Service Bulletin

Bulletin No.: PI1487

Subject: IPC Gauges Sweep, Loss of Power Steering Assist, Intermittent No Crank, Reduced Engine Power and Multiple U-Codes

Models: 2014-2015 Chevrolet Impala (VIN 1)
Built Prior to March 26, 2015

4206604

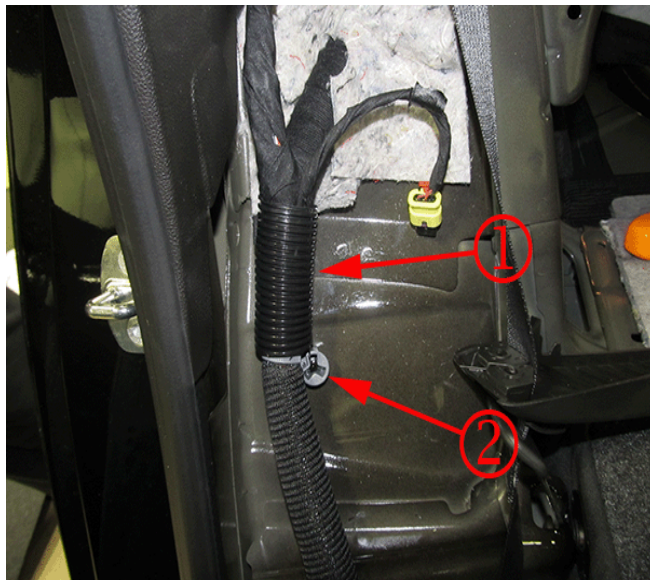
These symptoms may be caused by the right rear seat back bolster bracket contacting the body harness. The bracket may have rubbed passed the anti-abrasion tape and wiring insulation causing a short to ground.

3. Inspect the body harness (1) at this section above for any evidence of affected wiring.
4. If no evidence of bracket interference, continue diagnosis. Refer to the appropriate Service Information.
5. Repair the wire or wires as necessary. Refer to the Wiring Repairs in SI.
6. Rewrap that section of the body harness with woven polyester electrical tape (PET) or equivalent anti-abrasion tape or electrical tape.
